TENNESSEE VALLEY AUTHORITY

In response to your letter to H. G. Parris dated October 26, 1982, subject "10 CFR 50 Appendix R, Section III.G," we have prepared the enclosed information. This information addresses the seven questions contained in your letter and incorporates supplemental information as a result of subsequent conference calls with your staff.

Request for Additional Information
Post-Fire Safe Shutdown Capability
Browns Ferry Nuclear Plant Units 1, 2, and 3
Docket Nos. 50-259, 50-260, and 50-296

FIGURE 3.1.1.1-57.2

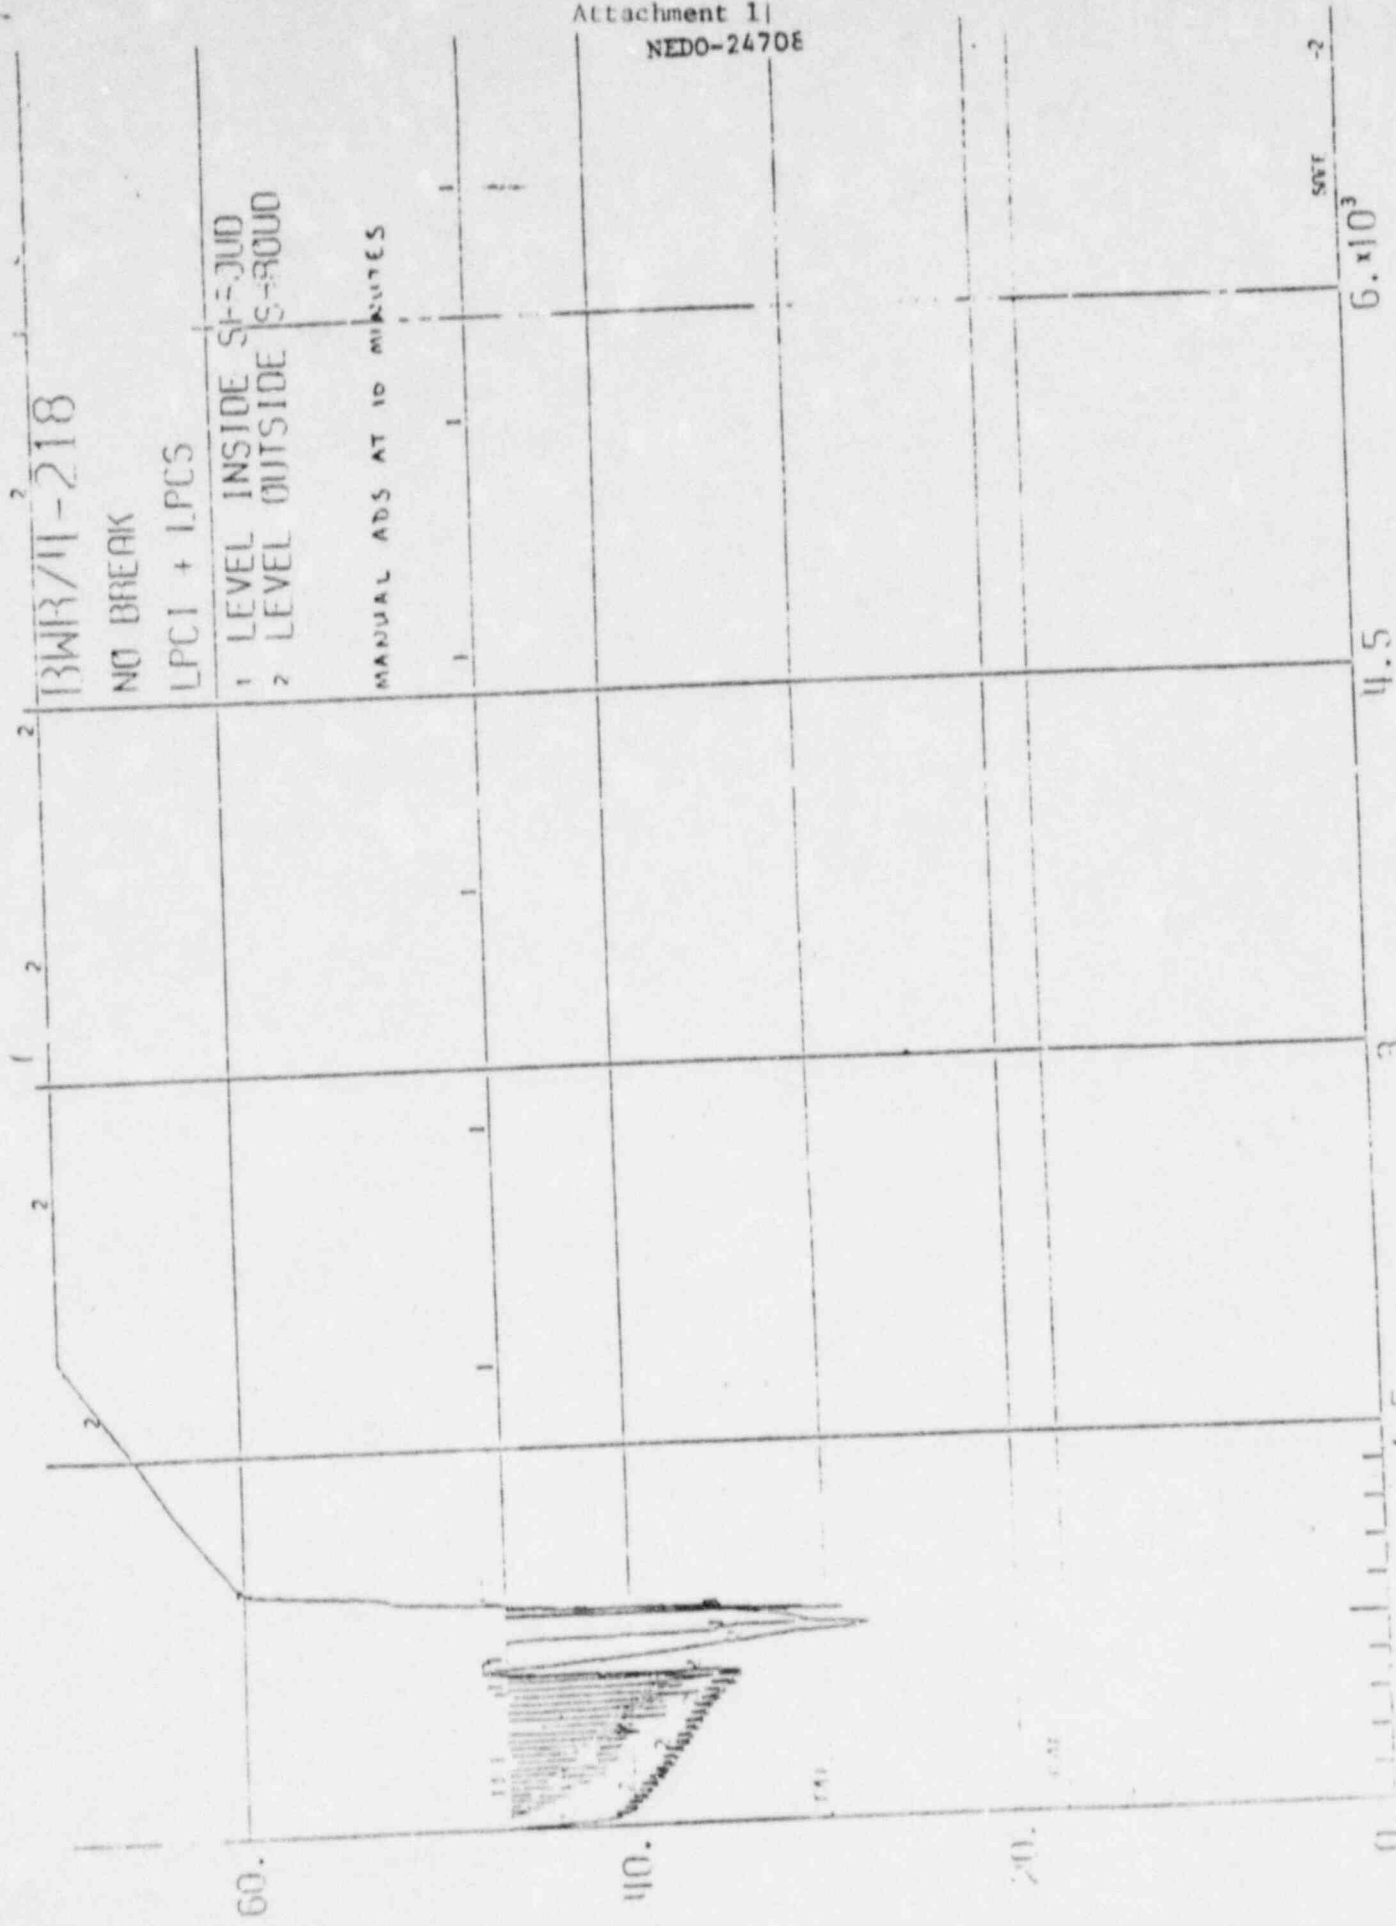
In your proposed method of alternate safe shutdown,

- A. How much of the core will be uncovered and for how long? How does this compare with the extent of core uncovering using normal shutdown facilities?
- B. What is the predicted peak torus water temperature?

- A. In a telecon between NRC and TVA on November 15, 1982, TVA agreed to provide additional information for the case of manual blowdown after ten minutes using four SRVs from the backup control panel with low pressure makeup consisting of one LPCI pump only. The results presented in attachment 1, which were obtained from NEDO-24708 entitled, "Additional Information Required for NRC Staff Generic Report on Boiling Water Reactors," are indicative of this case. The water level inside the shroud is shown to approach the TAF with recovery provided with low pressure makeup using one LPCI and two core spray pumps. The only difference between the subject case and the case presented in attachment 1 is the rate at which the water level is recovered. Due to the comparatively large contribution to level recovery by the LPCI pump, the water level inside the shroud is expected to stay near or above the TAF. If any core uncovering is experienced, it would be minimal, and sufficient reflood capability is easily provided by one LPCI pump to recover and maintain the water level above the core before any core damage occurs. These results are similar to several events which require emergency depressurization using the relief valves in manual or automatic mode.

FIGURE I
DIESEL FEED SYSTEM

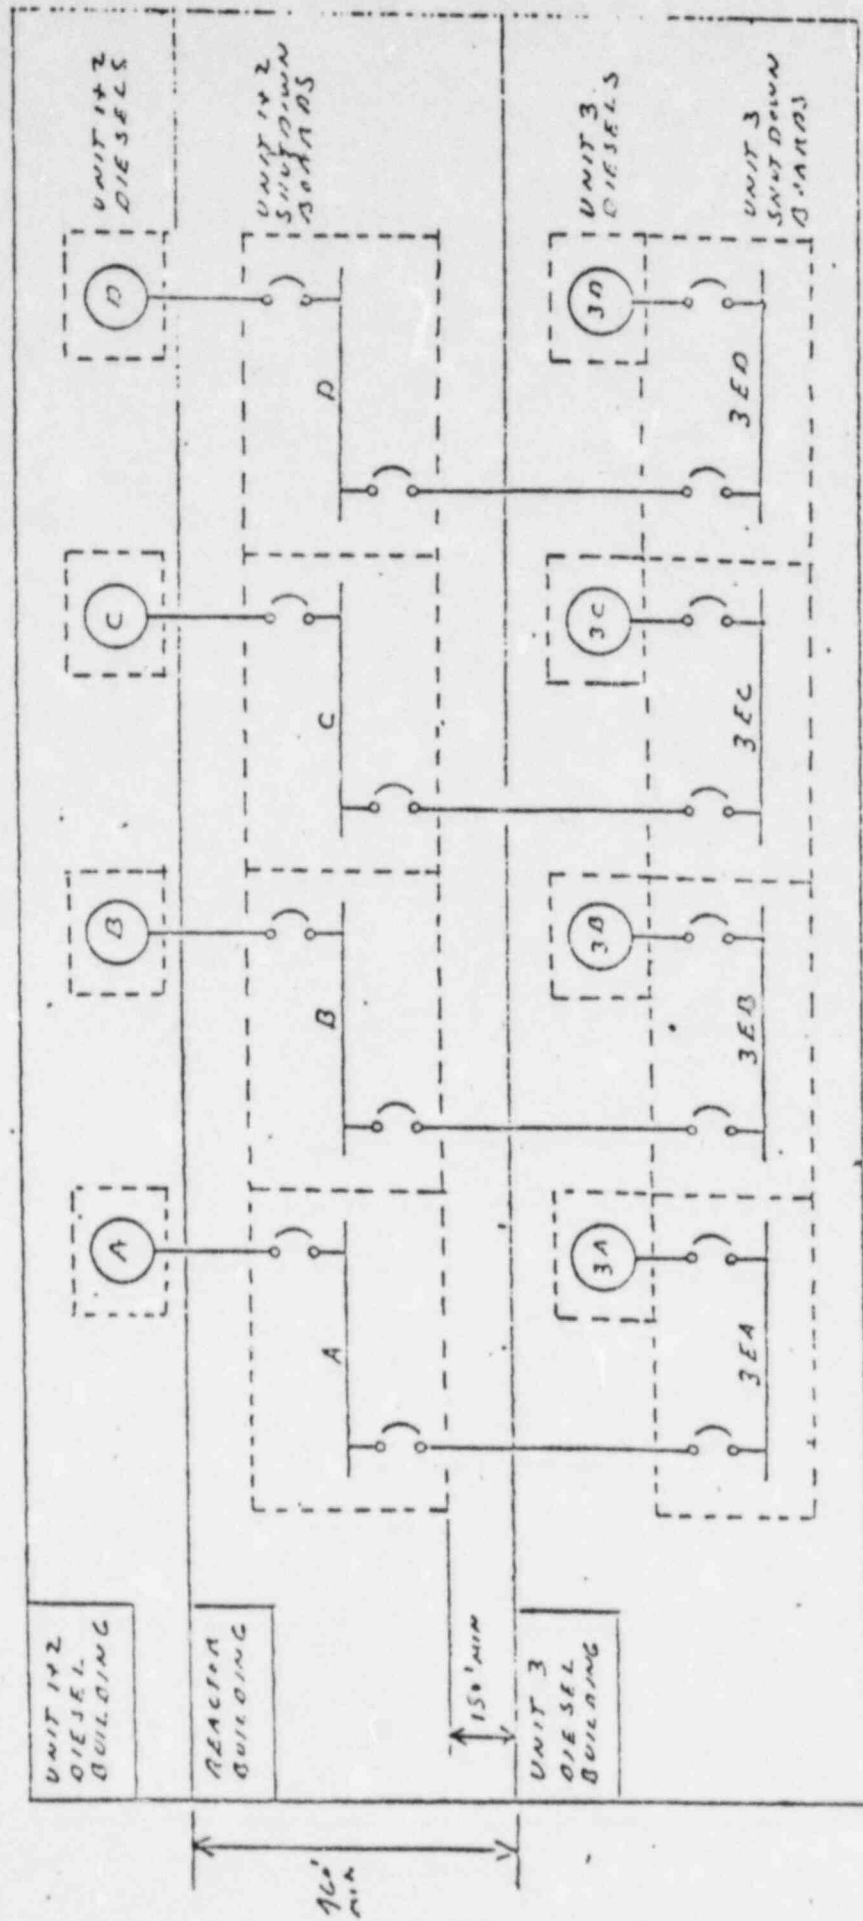
Have the following systems been considered in the alternate safe shutdown analysis? If not, provide justification for not including them.

- A. HPCI or RCIC,
- B. Emergency Diesel Generator.

- B. Yes. The emergency diesel generators (DGs) were considered, and it was shown that a minimum of four DGs would be available regardless of the fire area. The physical separation of the eight DGs (i.e., four at one side of the reactor building and four at the other side) precludes any power and control cables for one set of DGs being involved in a common fire with the cables of the other four DGs. The automatic logic and support systems were evaluated in attachment 2, "BFN Diesel Generator Automatic Start and Diesel Fuel Supply System Evaluation for Appendix R."

THE 4KV DIESEL GENERATOR POWER DISTRIBUTION SYSTEM IS SHOWN IN FIGURE I (SHEET 2)
